# Approved Revisions made to the Thesen Islands Design Guidelines

11.12.2024

## 11. D45-3: Boat Lifts

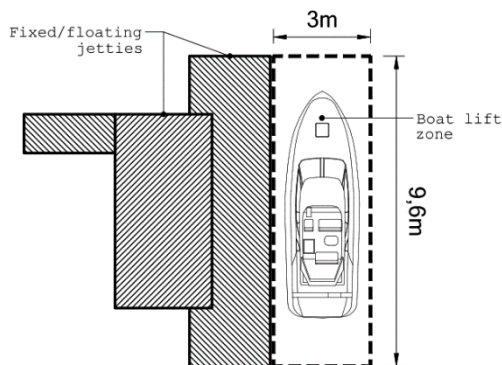
Additions / amendments:

These are not encouraged due to limited circulation space within waterways. Where viable, to be limited to a single boat lift unit, positioned within a 3.0m x 9.6m “boat lift zone” directly adjacent to the floating jetty:

- Only pre-approved types will be considered – specifications & colour to be submitted to the DRP for approval.
- No roofing or enclosures are permitted.

### 3. Floating boat lifts:

- To be limited to a single boat lift unit, positioned within a 3.0m x 9.6m “boat lift zone” directly adjacent to the floating jetty.
- Location, specifications & colour to be submitted to the DRP for approval. Preferred colour: NCS Midgrey
- No roofing or enclosures are permitted.
- No branding permitted. Float Lifts: Subject to DRP location approval - Only TIHOA approved Float Lifts allowed
- Approval is at the discretion of the TIHOA and TIDRP
